DRAFT DETERMINATION – PARTICIPANT RESPONSE PACK

METER CHURN PACKAGE

Participant: Endeavour Energy

Proposed new diagram for Figure 1 in FRMP Churn procedure:

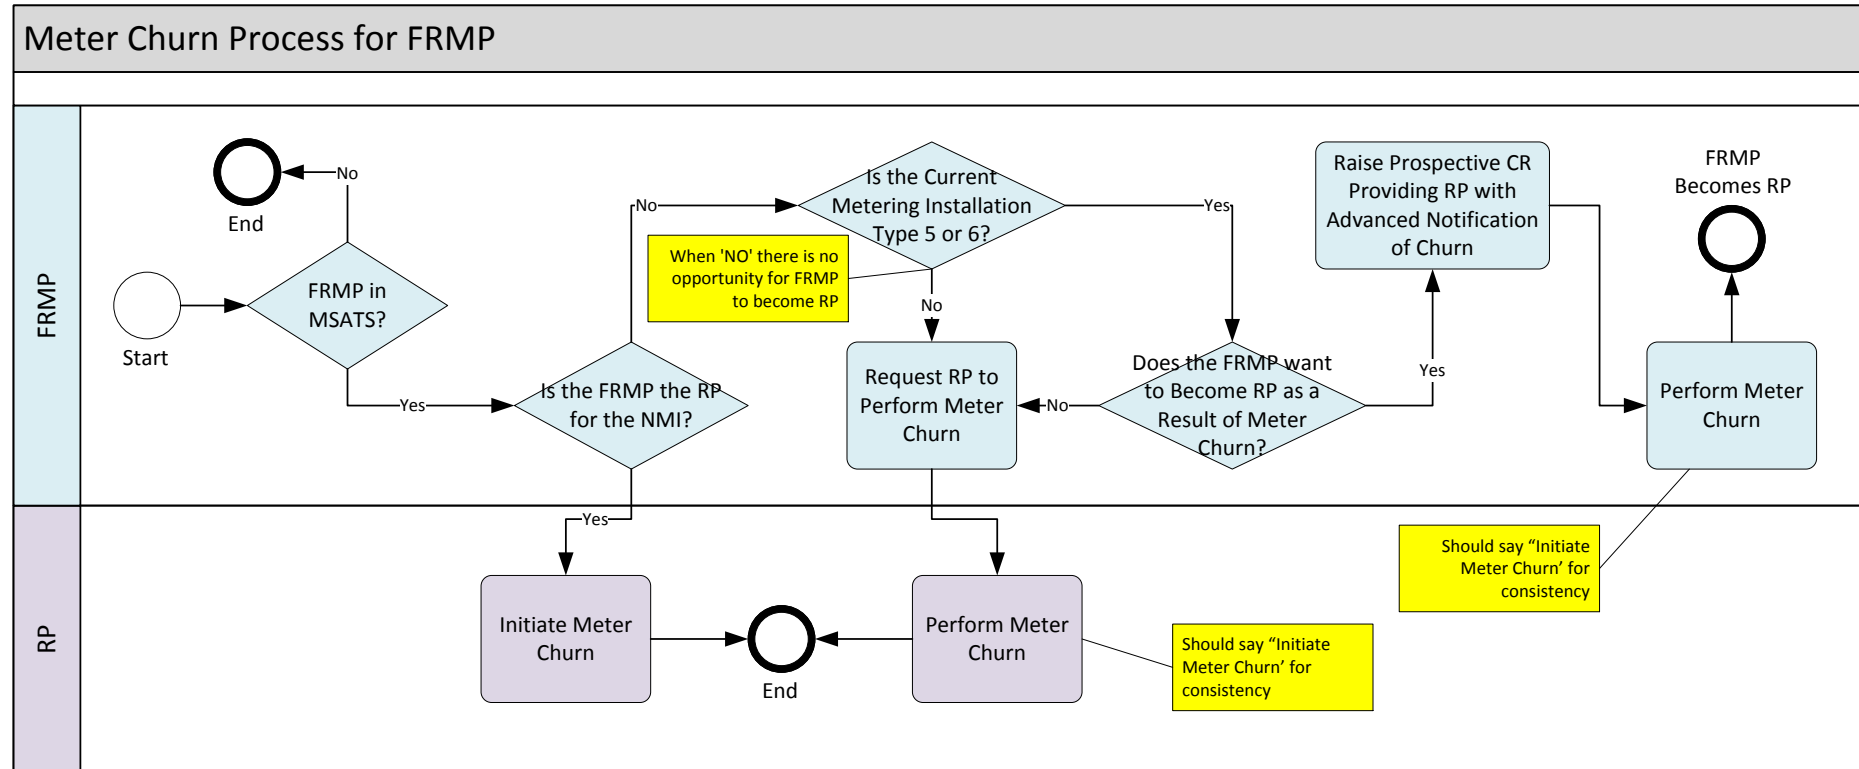
2.2	<p>FRMP Churn Procedure, Figure 1 (page 5)</p> <p>The diagram does not allow a FRMP to become the RP when the existing site has a type 1 - 4 meter and the FRMP is not the currently the RP. Suggest that the diagram is modified as shown below in appendix A.</p>		<p>The FRMP has the right to become the RP should they wish. The diagram should reflect this.</p> <p>Two of the action boxes changed from 'perform meter churn' to 'initiate meter churn' to align with the text in the document.</p> <p>Also tidied up the diagram to make it easier to read.</p>
